# Connecting Palo Alto Projects

## Caltrain Technical Review

# Vertical Alignment (Correction)

# Summary of Comments – Meadow Dr & Charleston Rd - Viaduct

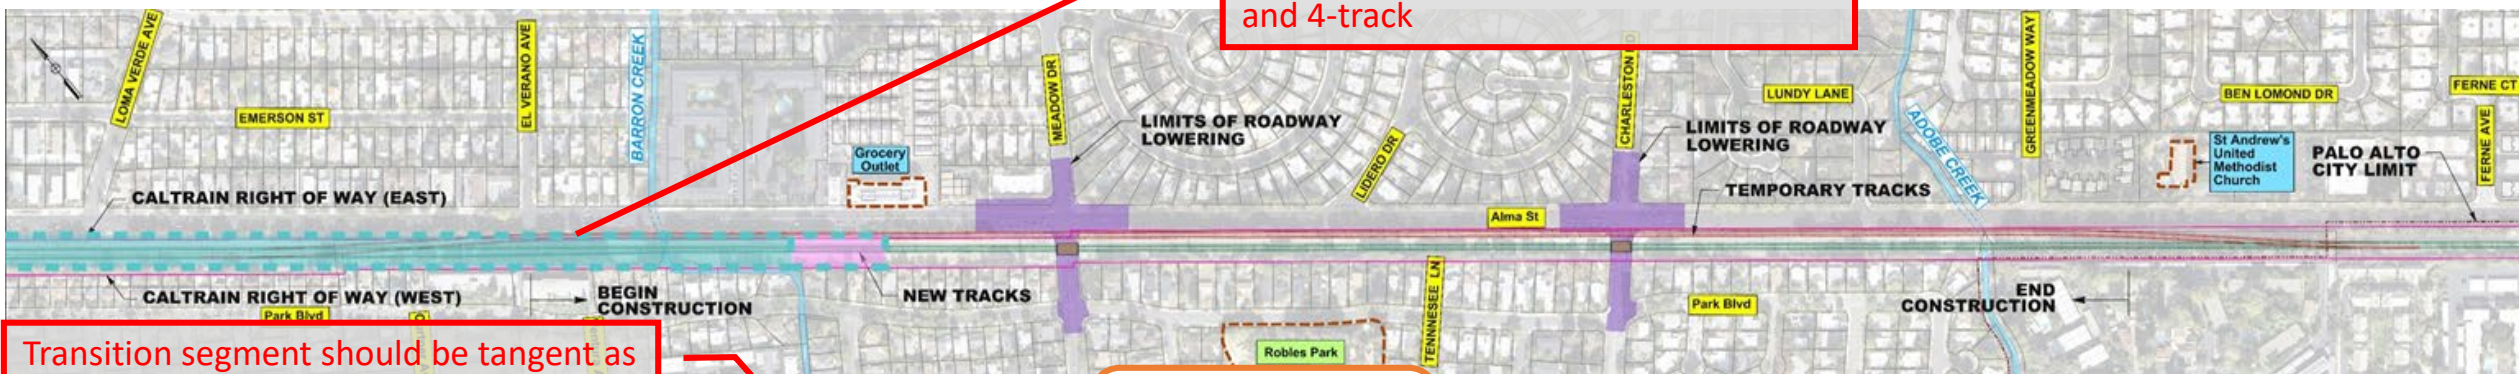
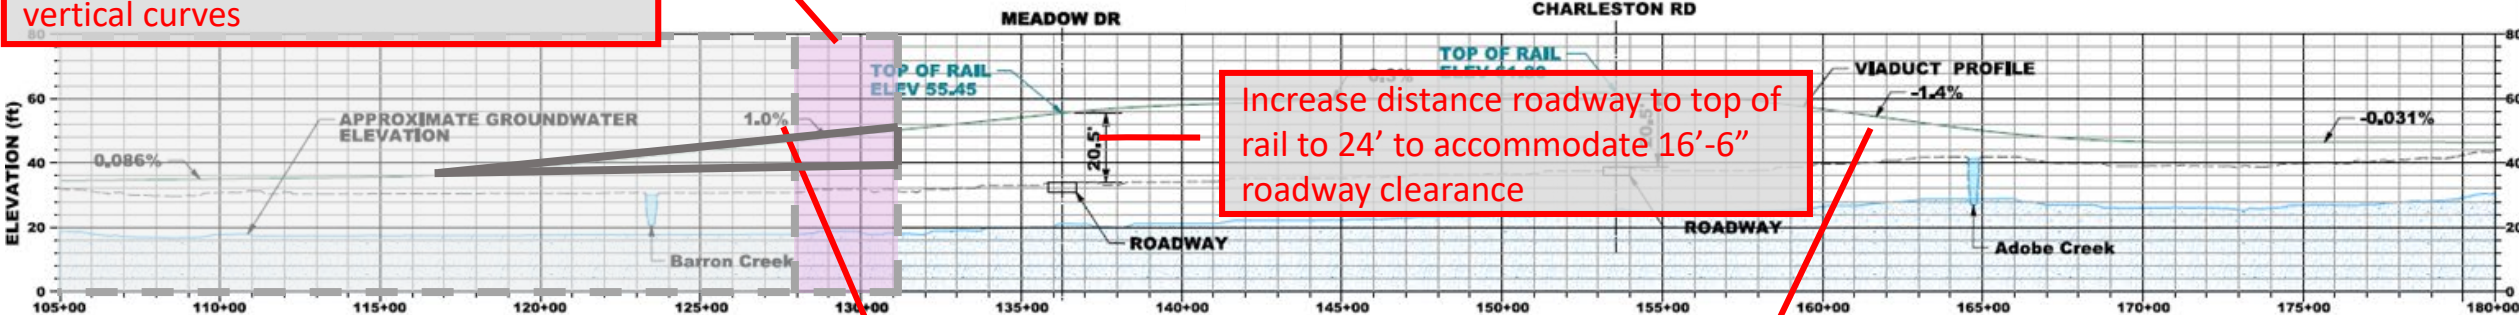
4-Track Influence Area     Transition between 2-Track and 4-Track

Fill retaining walls to accommodate 4-track and transition between 2-track and 4-track

Transition segment should be tangent as special trackwork should stay outside of vertical curves

Increase distance roadway to top of rail to 24' to accommodate 16'-6" roadway clearance

Design speed is 110 mph for passenger rail

1% grade is the current maximum without variance. 1% to 2% grade requires review and approval by the Director of Engineering
